STAFF REPORT 10-09-2019 REGULAR MEETING

APPLICATION NUMBER: 19-6477 **ADDRESS:** 19512 CANTERBURY ROAD

SCOPE: REPLACE EXISTING WOOD WINDOWS WITH VINYL WINDOWS

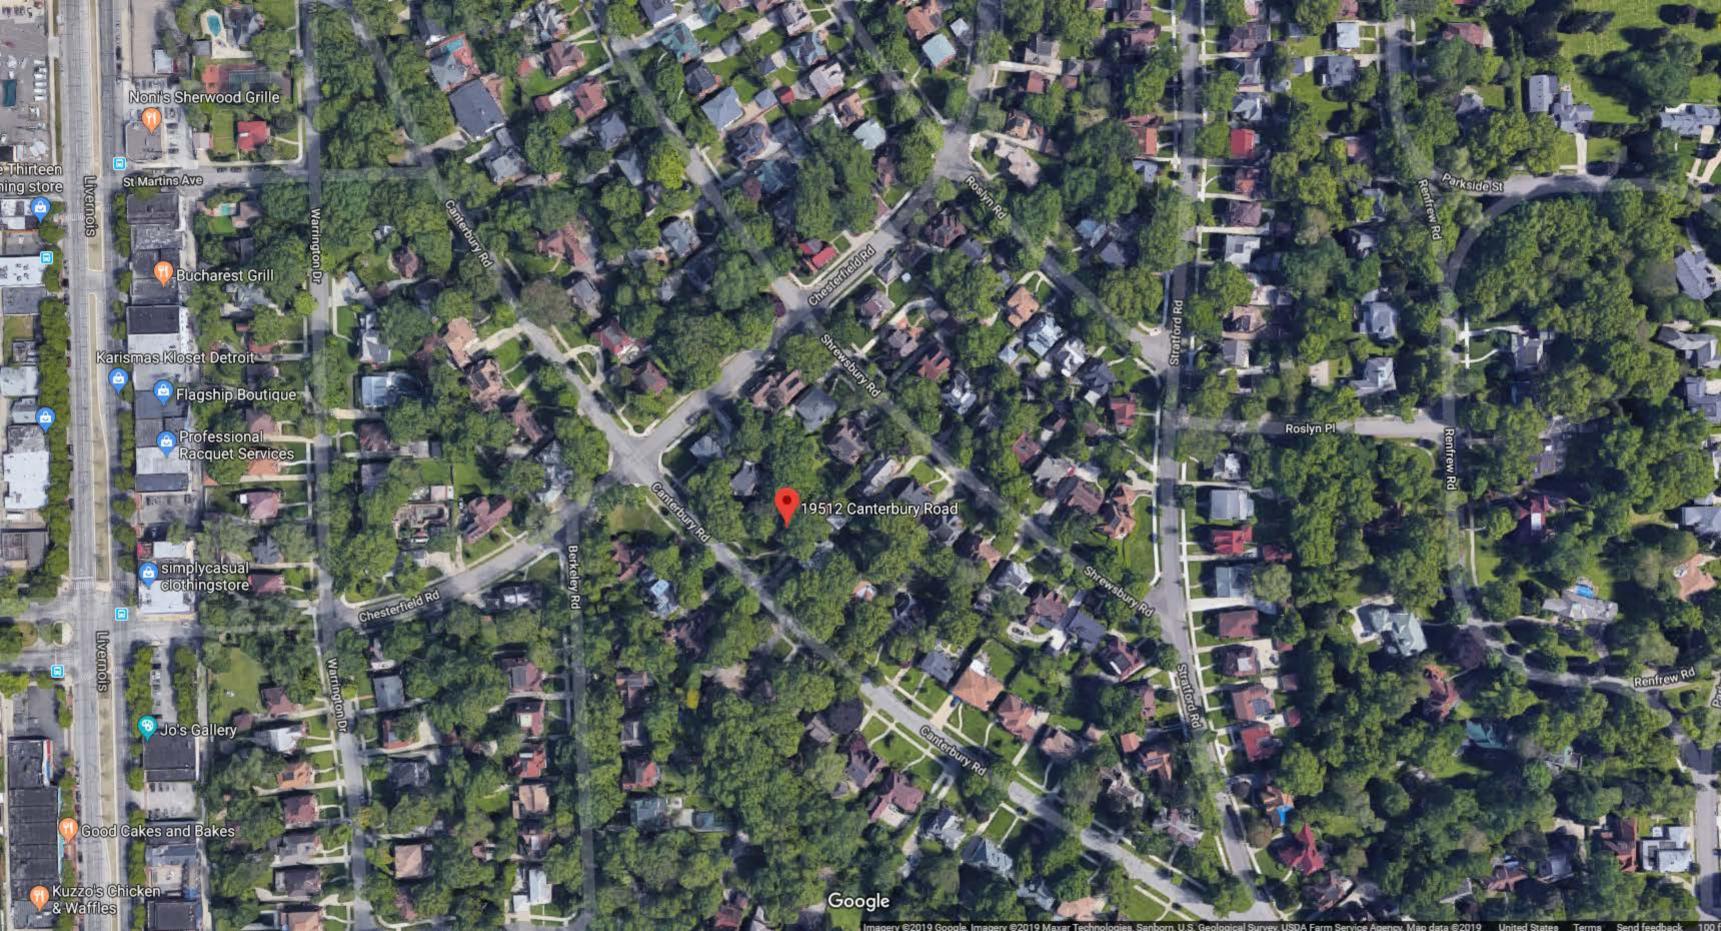
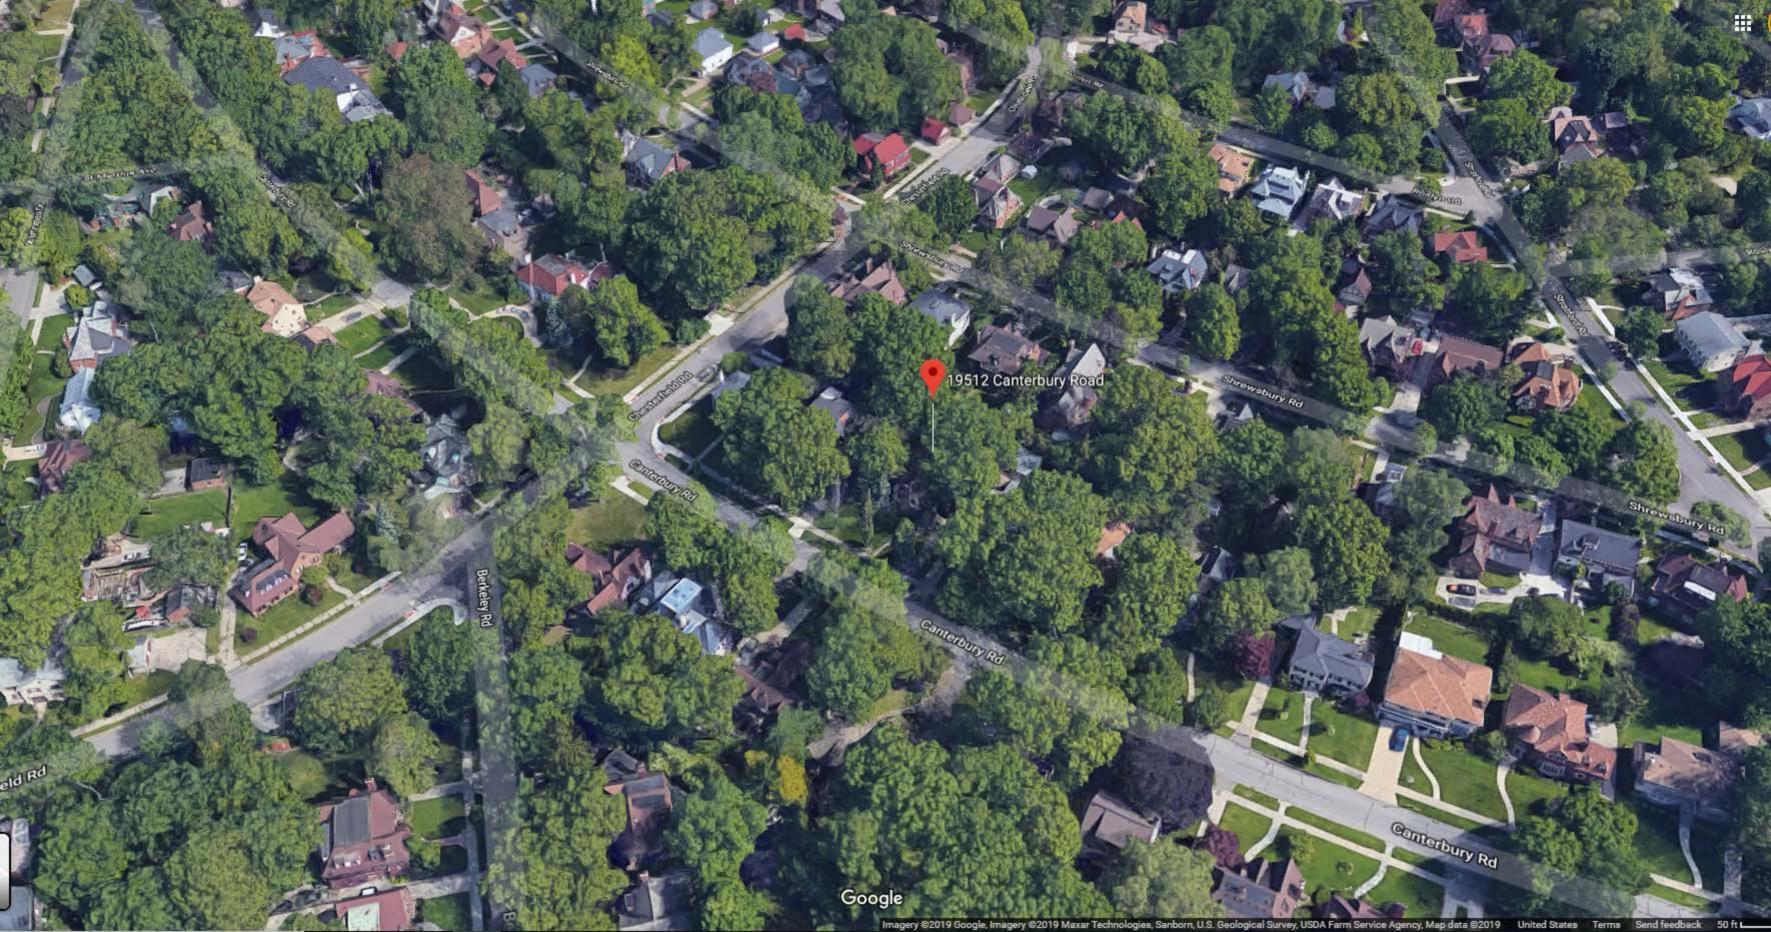
• The windows appear to be in good condition

- The contract included in the application lists existing leaded-panel casement windows as "sliders" and is proposing to replace with vinyl sliders.
- Applicant is not proposing replacement due to deterioration and therefore did not provide documentation regarding the level of deterioration of the existing windows.
- Applicant did provide one estimate for repair but was unable to obtain a second estimate. According to the applicant, the company that provided the estimate for repair stated that it appeared as though the windows simply needed to be repainted rather than replaced.

It is staff's opinion that the work, as proposed, destroys historic materials that characterize the historic building, its site, and setting. Staff therefore recommends that the Commission deny a Certificate of Appropriateness as the proposed work does not meet the following Secretary of the Interior's Standards for Rehabilitation:
